System Impact Assessment Report (Addendum)

CAA ID: 2010-403/406/408/409
Project: Northland Power Solar Martin's Meadows,
Abitibi, Long Lake and Empire
Applicant: Northland Power Solar Martin's Meadows,
Abitibi, Long Lake and Empire L.P.

Document ID	IESO_REP_0753
Document Name	System Impact Assessment Report (Addendum)
Issue	Final Report
Reason for Issue	Final Report
Effective Date	May 15th, 2012

Figure 5: P13T – LLG Fault @ Porcupine

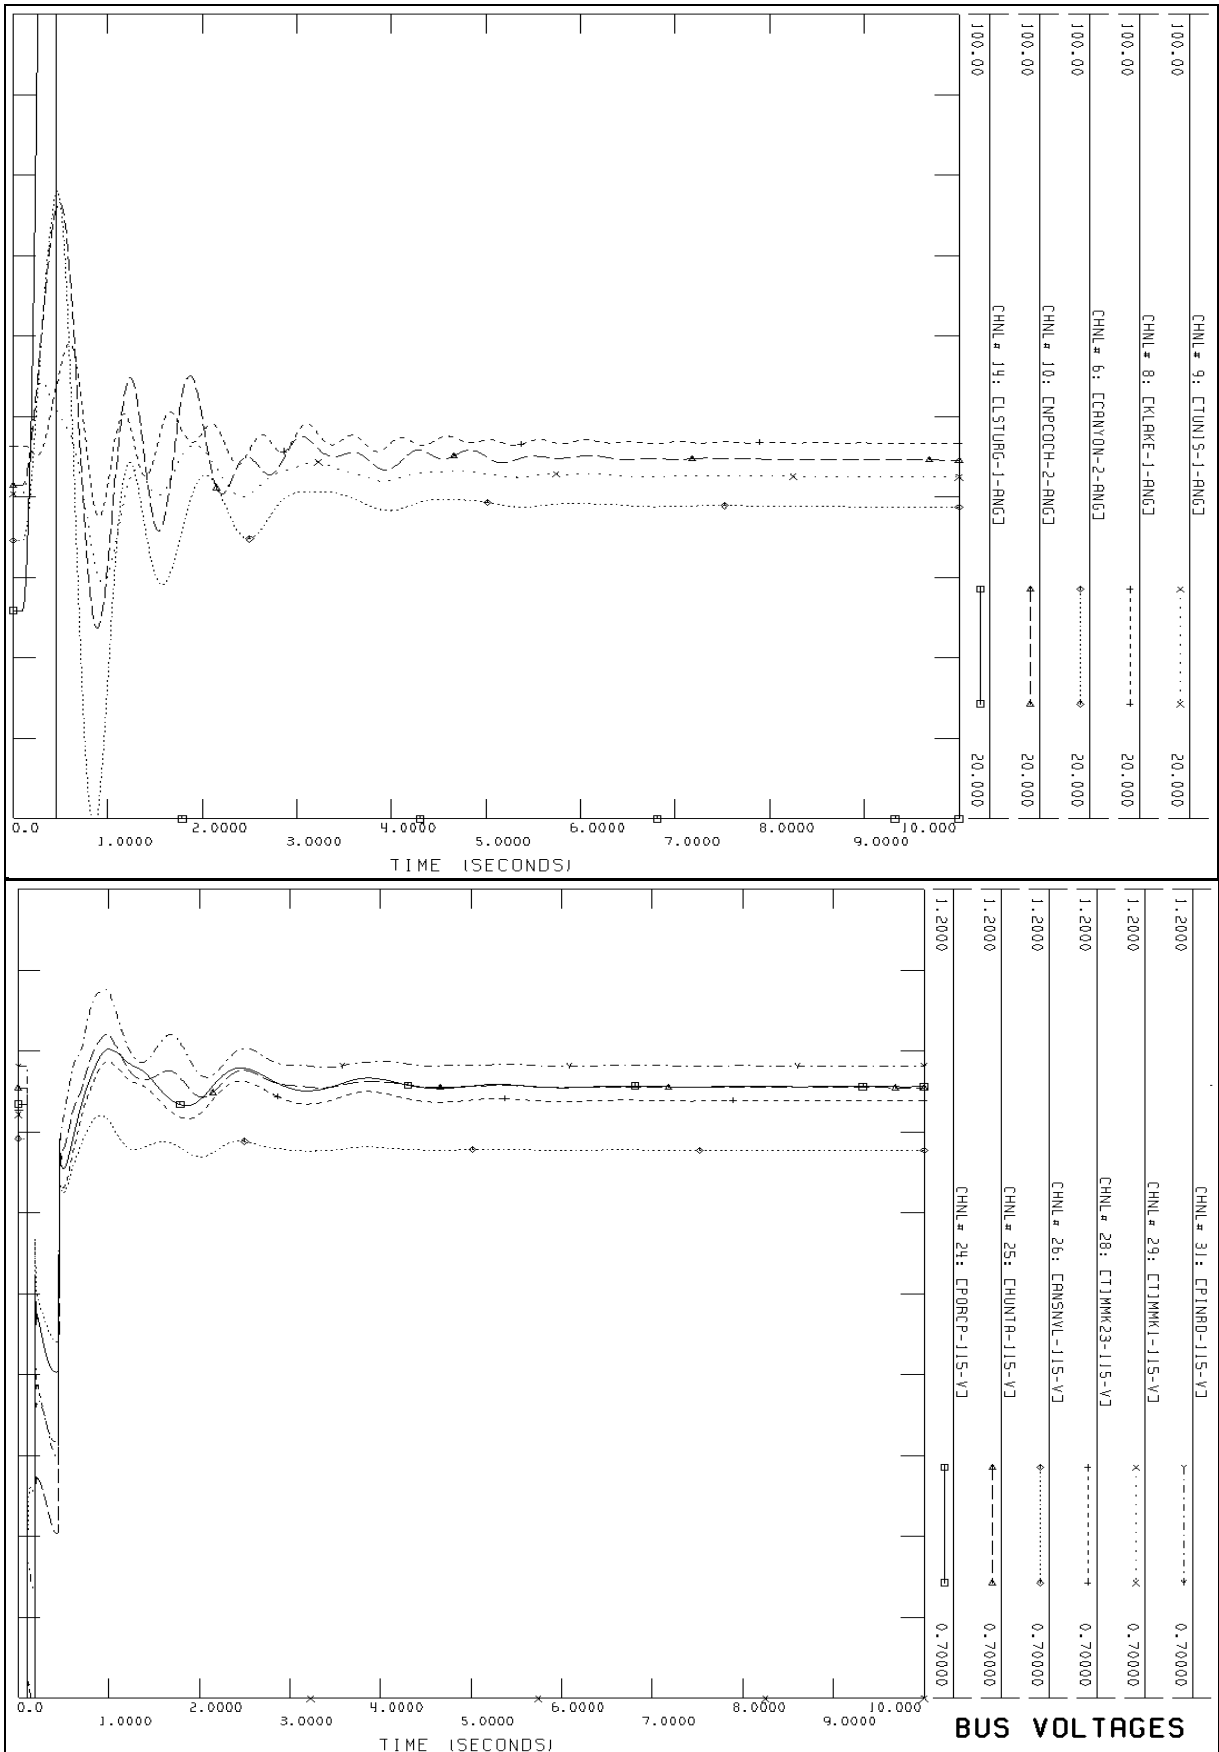
Transient simulations for the P13T @ Porcupine contingency resulted in the transient instability of the Lower Sturgeon generators. Due to the small size of these embedded units and the fact their instability does not propagate to the rest of the system, this does not pose any reliability concerns to the IESO controlled grid. Plots of all local generator angles during this fault are shown in Figure 5. Lower Sturgeon units are tripped when their rotor angles reach approximately 360 degrees to simulate their generator out-of-step protections. All other units remain stable and show well-damped angle oscillations.

Figure 10: NP Solar Abitibi Inverter Terminal Voltage for Studied Contingencies

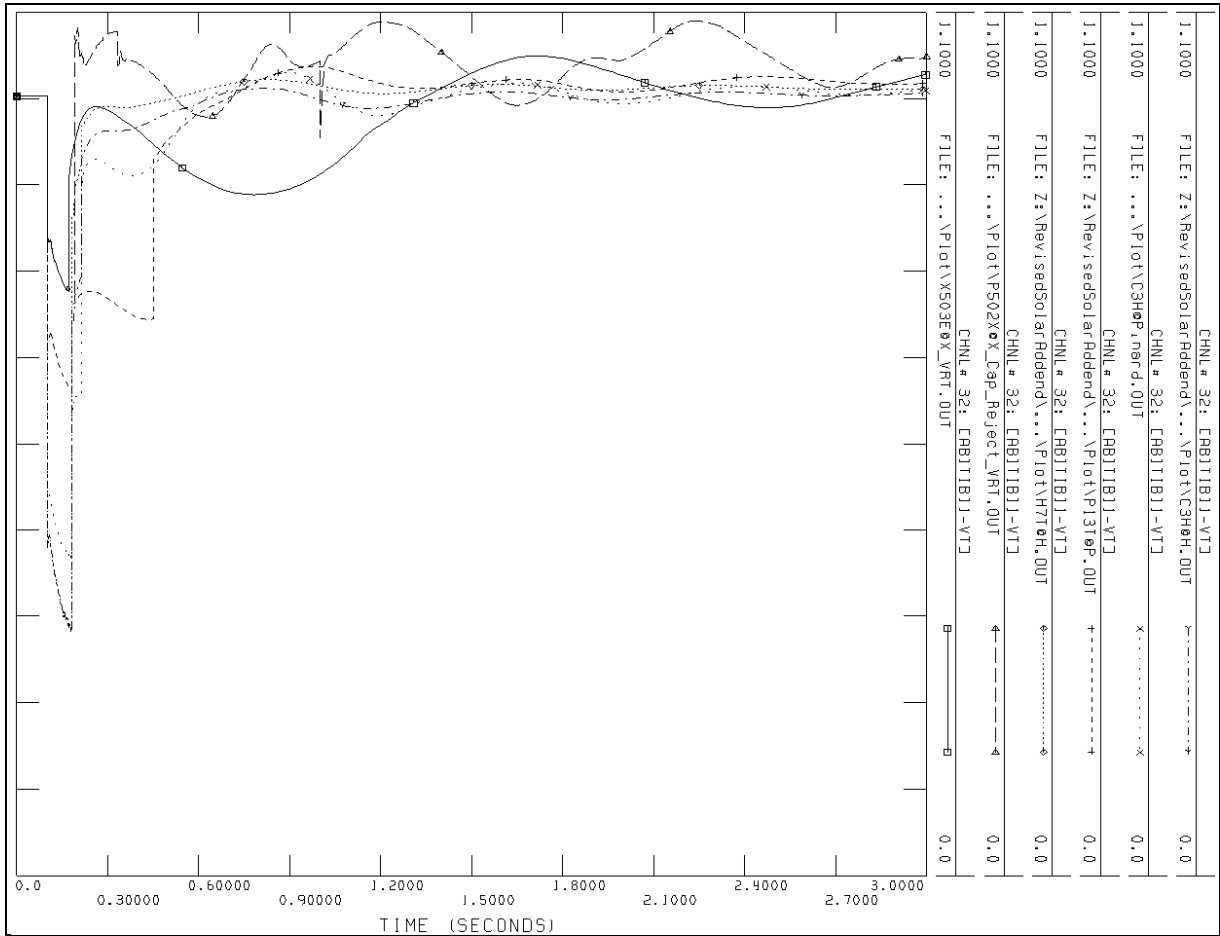
Using the summer normal peak case, The VRT capability of the inverters was assessed based on the terminal voltages of the inverters under the simulated contingencies in Table 17. Figure 10, Appendix A shows the terminal voltages of the inverters at the Martin's Meadow site. It shows that the terminal voltages of the inverters remain below 0.75 pu for about 200 ms, and recover to within 0.9 – 1.1 pu in less than 400 ms after the fault inception. As compared with the VRT capability of the SMA 800CP, the proposed inverters are able to remain connected to the grid for recognized system contingencies that do not remove the project by configuration.

Figure 11: C2H@ Hunta Impedance Trajectory for LLG fault on C3H @ Hunta

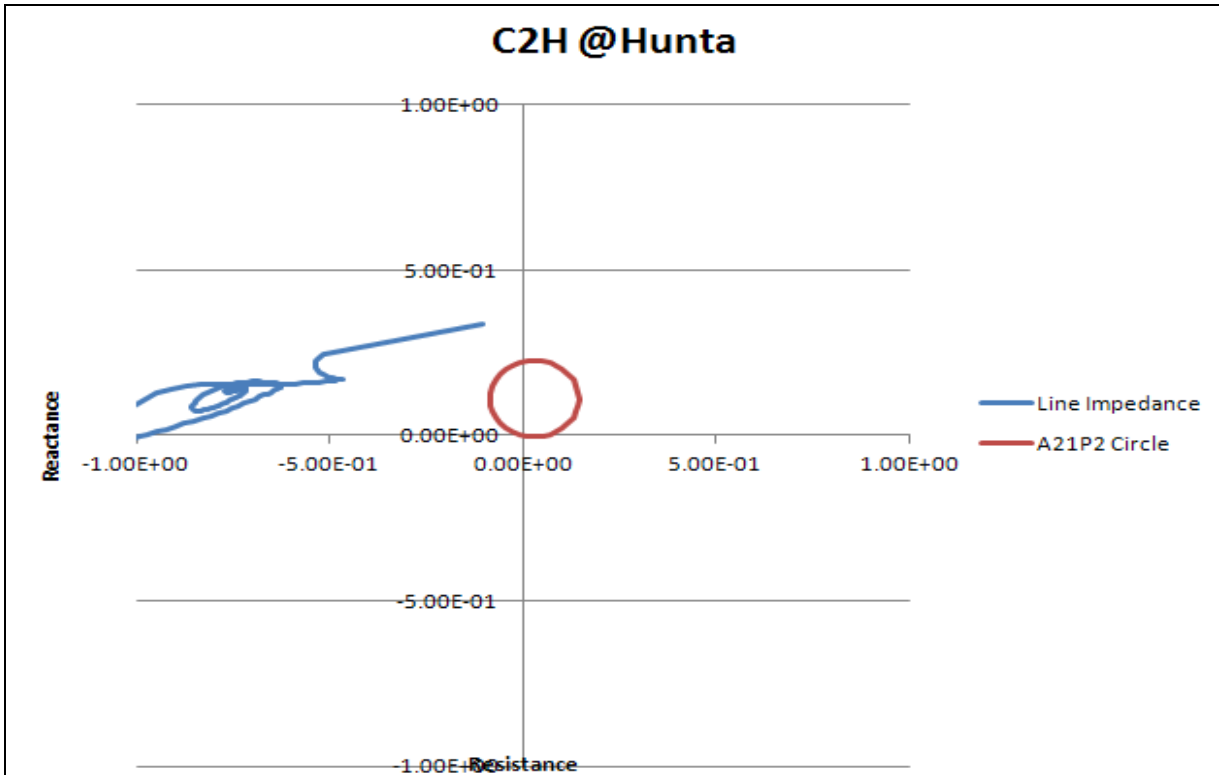
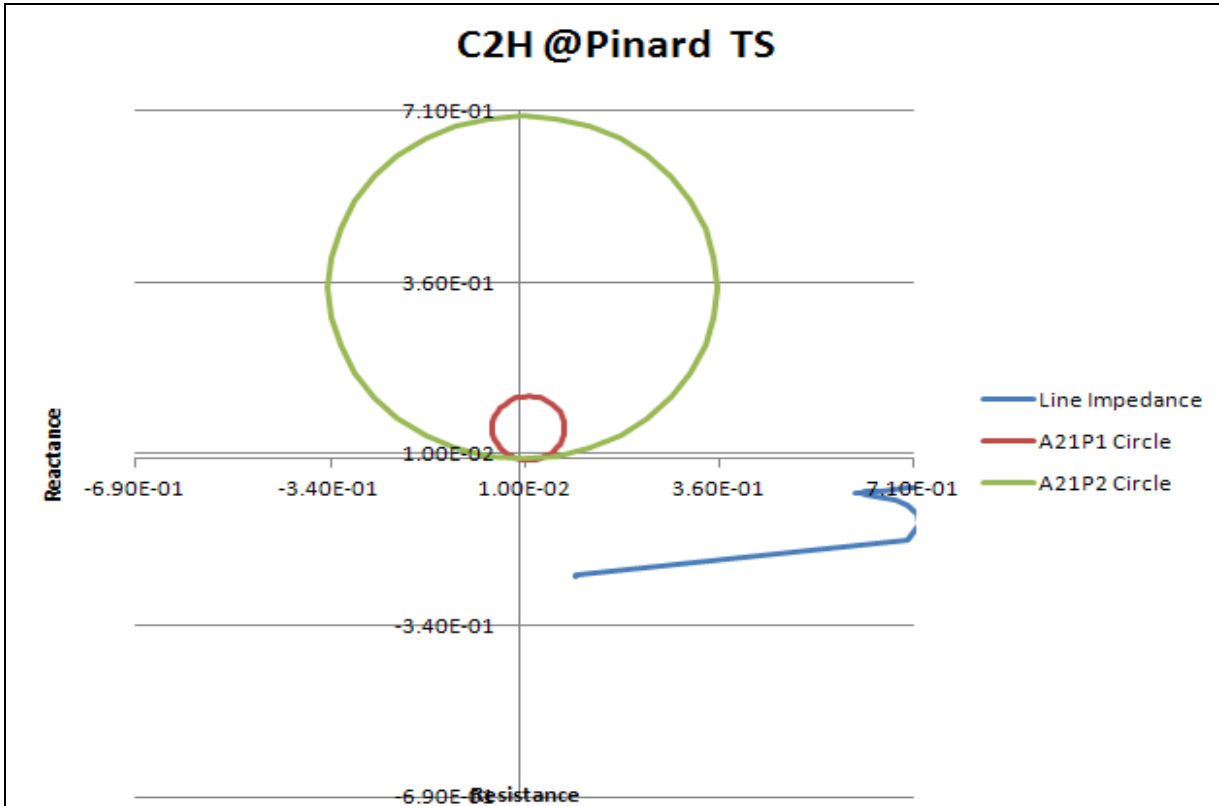
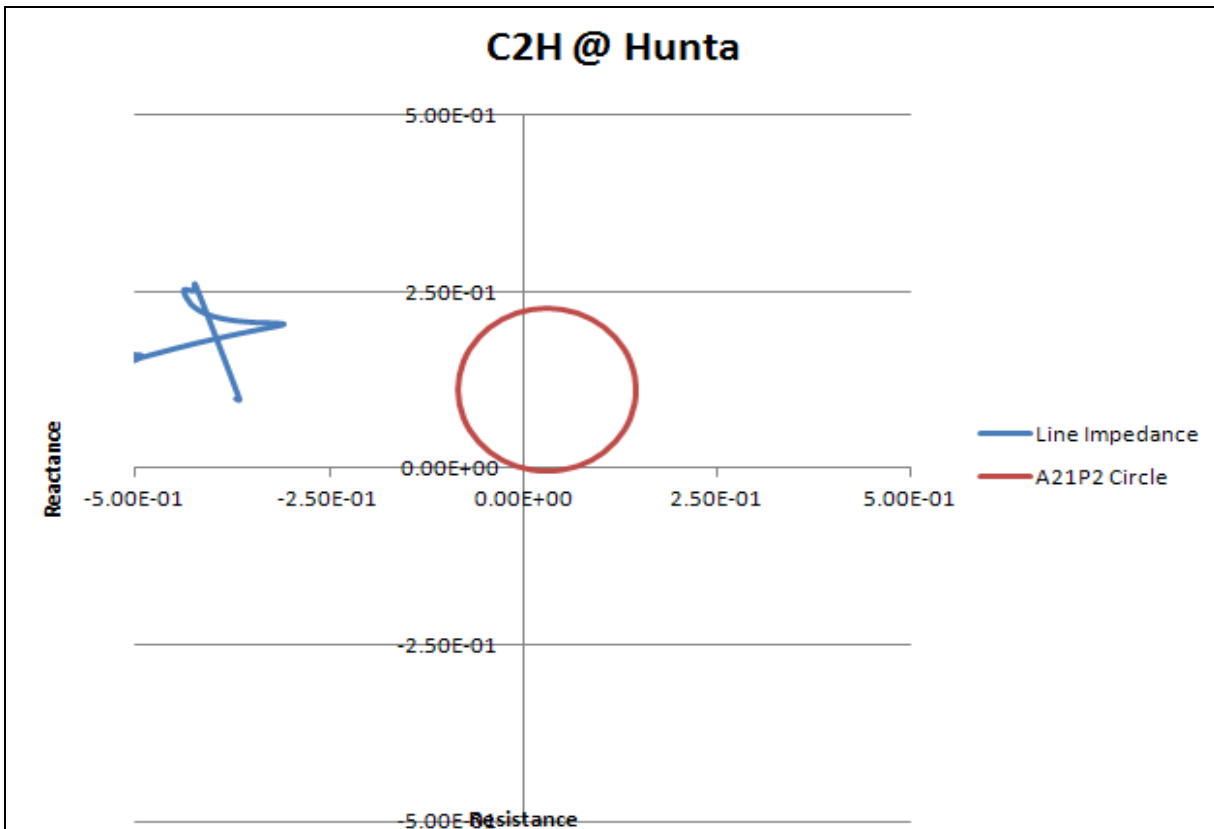
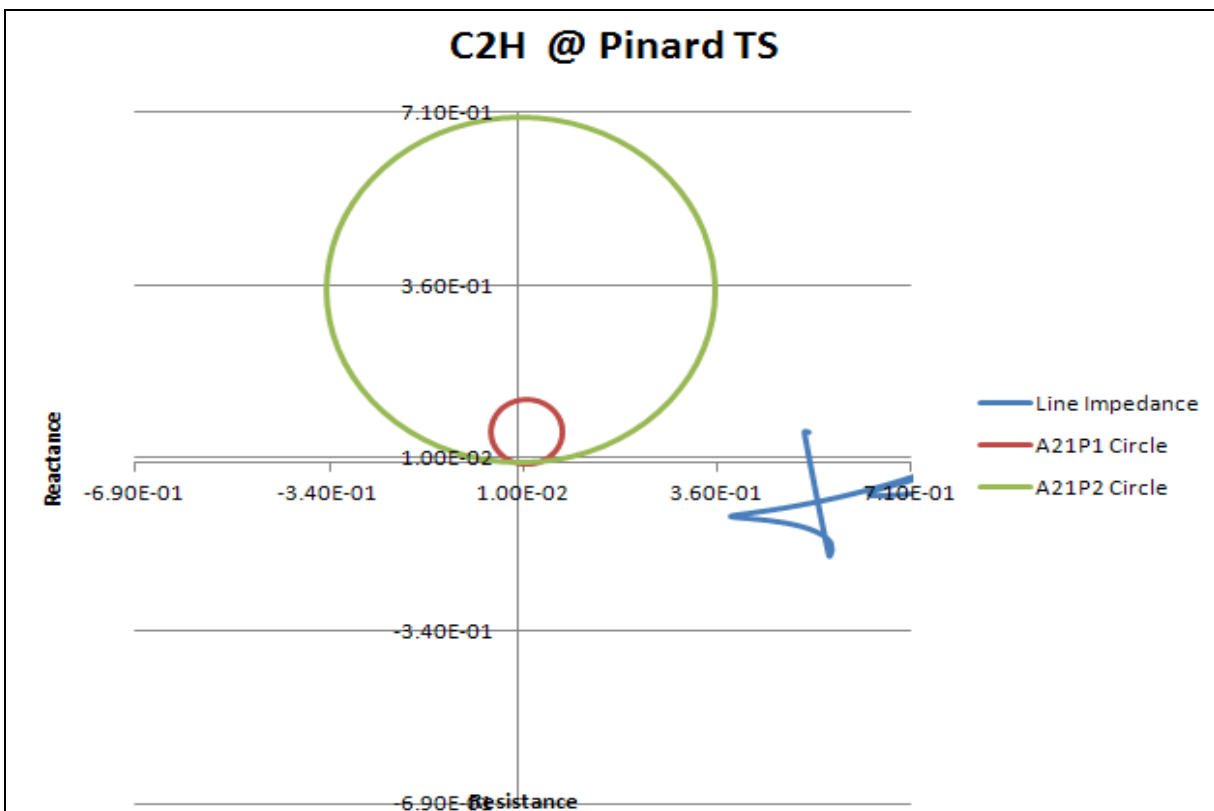
Relay margin plots shown in Figure 11 to Figure 14, Appendix A show that the trajectory on circuit C2H does not penetrate the relay characteristic with a margin of greater than 20%, thereby meeting the Market Manual requirement and verifying that circuit C2H will not trip for out of zone faults.

Figure 1: 40 MVA Solar Generation Connection to HONI Transmission System

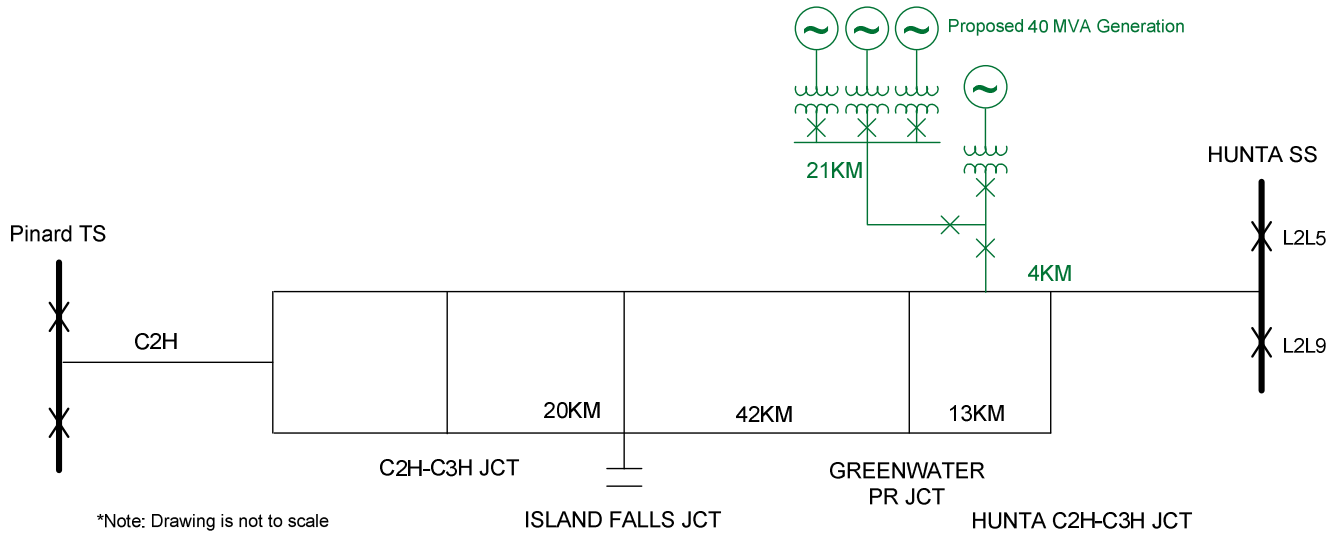
It is feasible for Northland Wind Farm to connect the proposed 40 MW generation at the location in Figure 1 as long as the proposed changes are made:

The existing Zone 1 reaches at both terminal stations will be modified to accommodate the new connection. The existing Zone 2 reaches at both terminal stations will be modified to cover the maximum apparent impedance due to the connection of the Northland Solar Generators. The existing permissive overreaching scheme will have to be converted into a direct comparison blocking scheme.

The customer shall provide a redundant distance protection scheme to cover faults on C2H and shall be responsible to reliably disconnect their equipment for a fault on the line in case of a single contingency in their equipment. The customer is responsible for transmitting transfer trip, breaker fail, blocking and GEO signals. Conversely, the customer shall accept transfer trip signals from HONI terminal station and initiate its protection breaker failure in the event of line protection operation, and/or terminal station breaker failure operation.
